# AQUALLIANCE

January 19, 2010

**Subject: Comments on the Draft Environmental Assessment and Findings of No Significant Impact for the 2010-2011 Water Transfer Program**

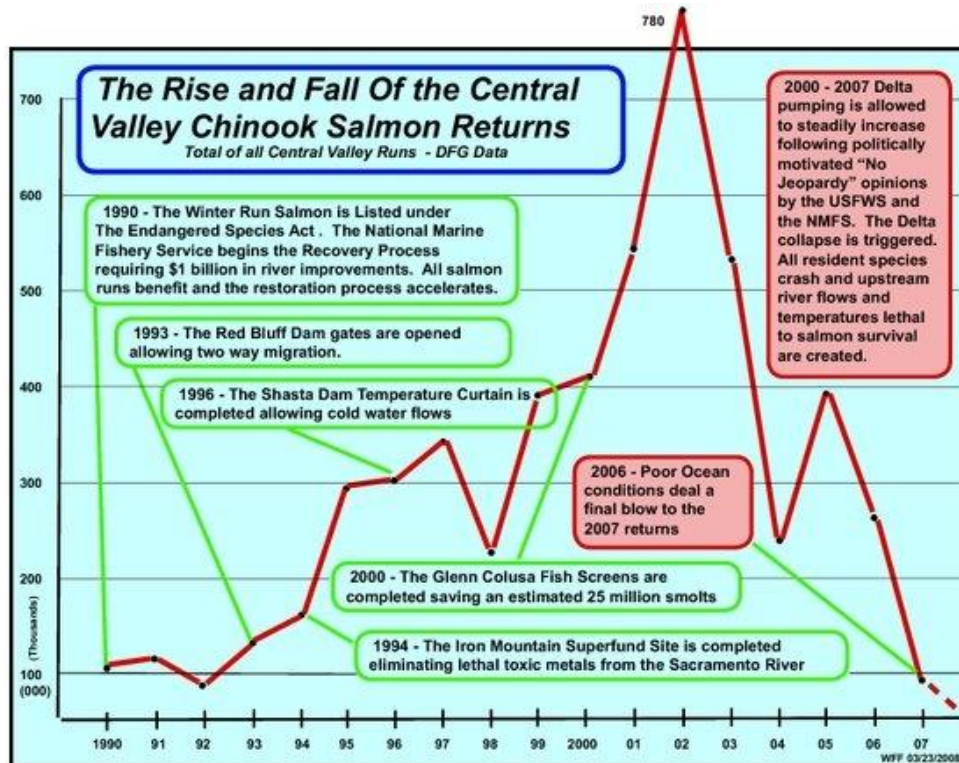
Unfortunately, the draft EA fails to anticipate possible stream flow declines in important salmon rearing habitat in the 2010-2011 Water Transfer Program area. Many important streams, such as Mud Creek, are located within the 2010-2011 Water Transfer Program and flows through probable Tuscan recharge zones, yet are not mentioned in the EA (also see comments above regarding Rock Creek). While a charged aquifer is likely to add to base flow of this stream, a dewatered aquifer would pull water from the stream. According to research conducted by Dr. Paul Maslin, Mud Creek provides advantageous rearing habitat for out-migrating Chinook salmon (1996). Salmon fry feeding in Mud Creek grew at over twice the rate by length as did fry feeding in the main stem of the Sacramento River. *Id.*
